ASSESSMENT REPORT

OLD CLARE HOTEL BLOCK 3A, CENTRAL PARK, CHIPPENDALE MP 11_0089 MOD 3

Figure 5: Key sensitive and nearby receivers potentially impacted by the proposal (Base source: Proponent's application)

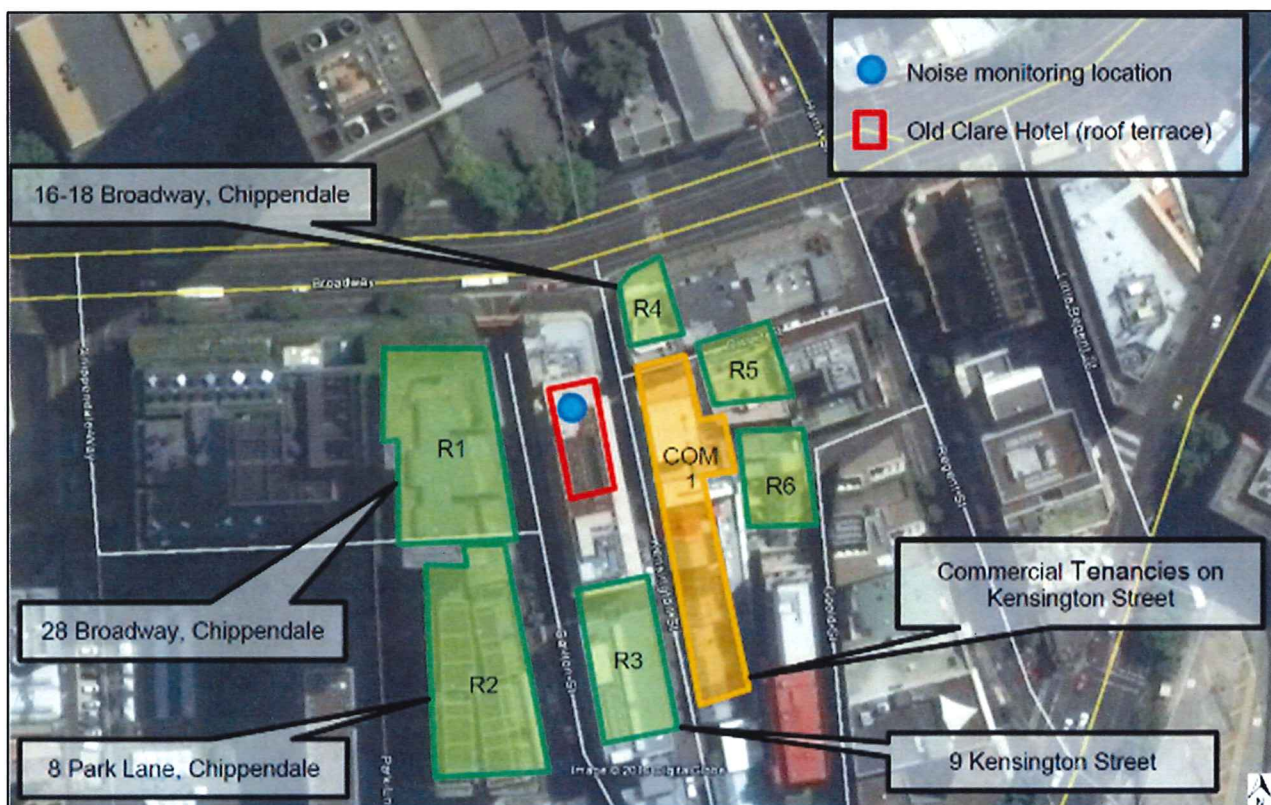
In support of the application, the Proponent submitted an Acoustic Assessment of the potential noise impacts on nearby sensitive receivers. The Acoustic Assessment identifies the nearest sensitive receivers (see **Figure 5**) are:

- R1 – 28 Broadway (residential)
- R2 – 8 Park Lane (residential)
- R3 – 9 Kensington Street (residential/student)
- R4 – 16-18 Broadway (residential)
- R5 – 1-5 Dwyer Street (residential)
- R6 – Goold Street (residential)
- COM1 – Tenancies on Kensington Street (commercial)

The Department considers the Acoustic Assessment has appropriately identified the sensitive receivers potentially affected by the proposal.

Figure 6: Proposed roof structure and single storey toilets (source: Proponent's application)

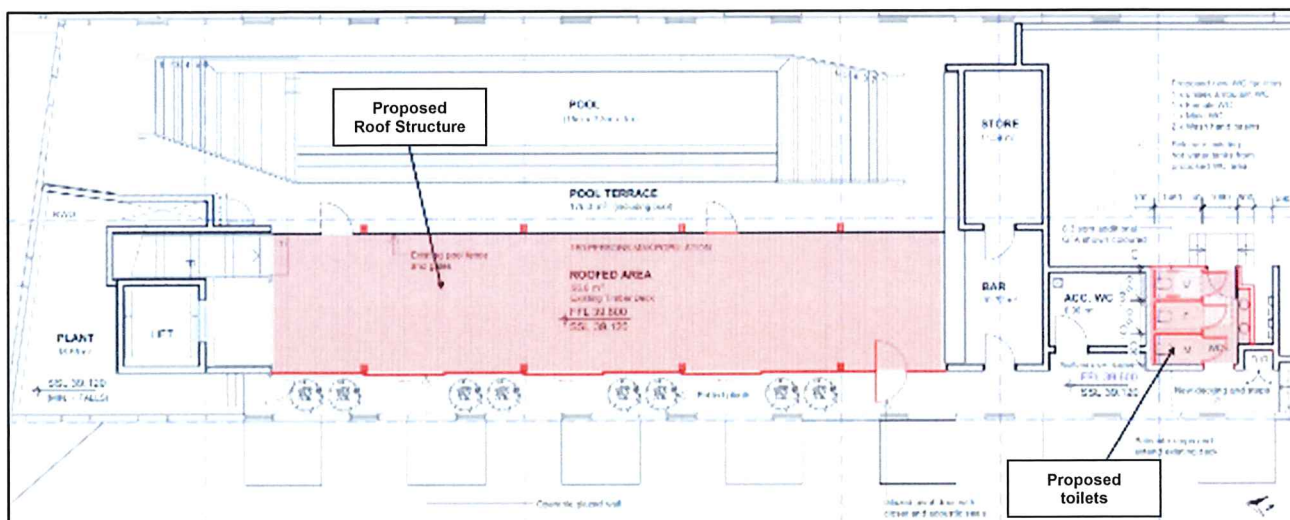
As described above, the proposed roof structure over the existing open terrace is required to provide acoustic protection to residents in apartments to the west of the site. The proposed roof structure (see **Figures 6 and 7**) would be:

- 21 m long, 3.1 m high and 4.6 m wide
- constructed of metal framed glazed walls, acoustic insulation, steel columns, and a metal roof with skylights
- set back 1.5 m from the western edge of the building, behind an existing 1.9 m high, glazed parapet

Concerns were raised about the design of the roof structure, including its height and visual impacts. Council also raised concerns about the proposed design of the roof structure, in particular, exceedance of the height control and impacts on views towards the sky from the public domain.

However, Council recommended the following changes should be made to the design to further minimise the visual impact of the proposal as viewed from the public domain, including:

- detailing a fine edge to the new roof rather than a deep fascia
- visually separating the roof plane from the wall planes
- minimising the bulk of vertical support structures
- providing a light, reflective soffit cladding, rather than the proposed concrete.

In response, the Proponent suggested the following changes could be made (by condition) to reduce the visual impact of the addition:

- soffit finish to be light grey gloss (as a reflective / mirror finish as suggested by Council would draw attention to the structure and increase visual clutter)
- skylights added to the western one metre edge of the roof is 40 % glazed to facilitate sky views from the public domain (refer to **Figure 7**)
- provision of more slender vertical supports within the constraints of the BCA, with details to be provided at detailed design / Construction Certificate stage.

In response to other Council suggestions, the Proponent notes the roof edge as designed, presents a fine edge detail and would be barely perceptible from the public domain. Further, for acoustic reasons, the roof cannot be physically separated from the walls.

The Department agrees the proposed modifications suggested by the Proponent (including the slender vertical supports, light grey soffit finish and skylights) would reduce the massing of the structure and increase views to the sky. Subject to these changes, the Department considers the proposal would have an acceptable appearance when viewed from the public domain. The Department has therefore incorporated these changes into the recommended conditions.

Figure 7: Sky views through the existing parapet (left) and proposed (right), including the proposed roof structure setback and height (Source: Proponent's Rts)

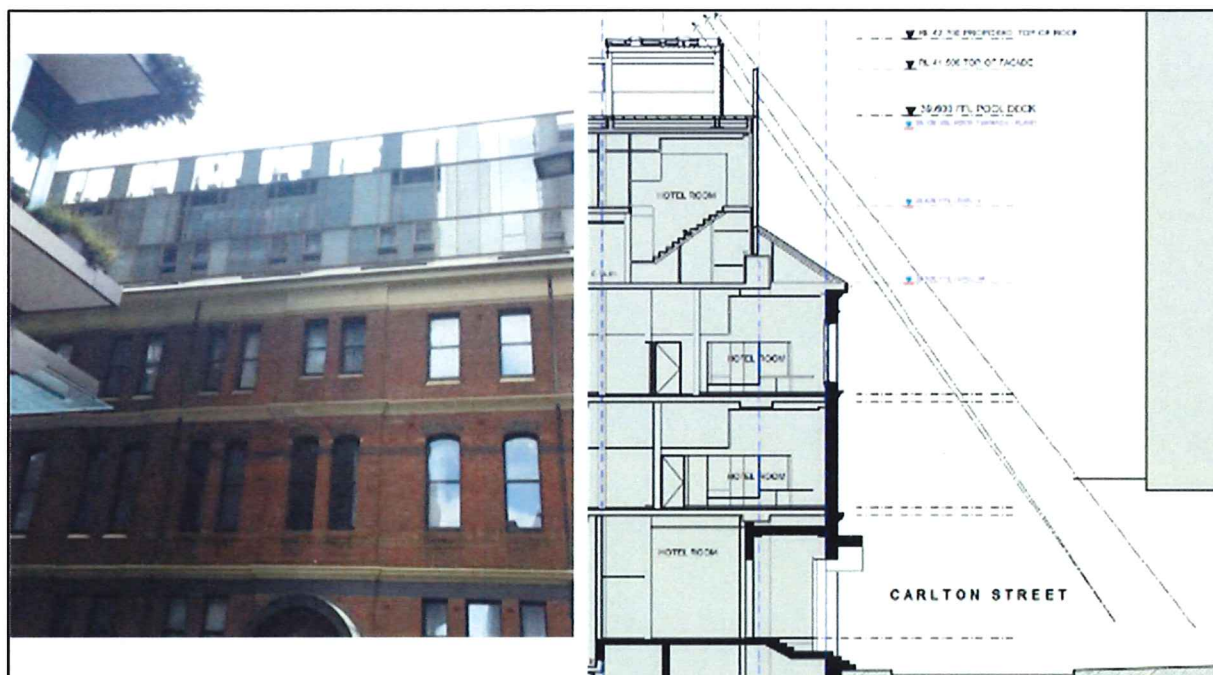
The Proponent noted the proposed roof structure (RL of 42.7), would exceed the approved Concept Plan building envelope height (RL 41.5) by 1.2 m. However, the Proponent notes the exceedance is minor, below the height of the approved lift overrun (which also exceeds the Concept plan height), remains below the height of many surrounding buildings, and therefore meets the objectives of the control.

Following the Proponent's response, Council raised no further concerns with the design or height of the proposed roof structure.

The Department considers the proposed roof structure would not result in any unacceptable visual impacts when viewed from the public domain. As demonstrated in **Figure 7**, the structure would be set back 1.5 m from the parapet edge, and would not be highly visible from the footpath on Carlton Street.

With regard to the height of the proposed structure, the Department considers the variation from the height control (by 1.2 m) is minor and acceptable as the structure would:

- be set back 1.5 m from the building edge, significantly reducing its visibility from the street
- be constructed of visually light-weight materials, including glazing thereby increasing its transparency
- not have an adverse impact on the heritage significance of the building
- be consistent with other existing structures on the roof that exceed the Concept Approval maximum building envelope height by a greater degree (+ 2.7 m).
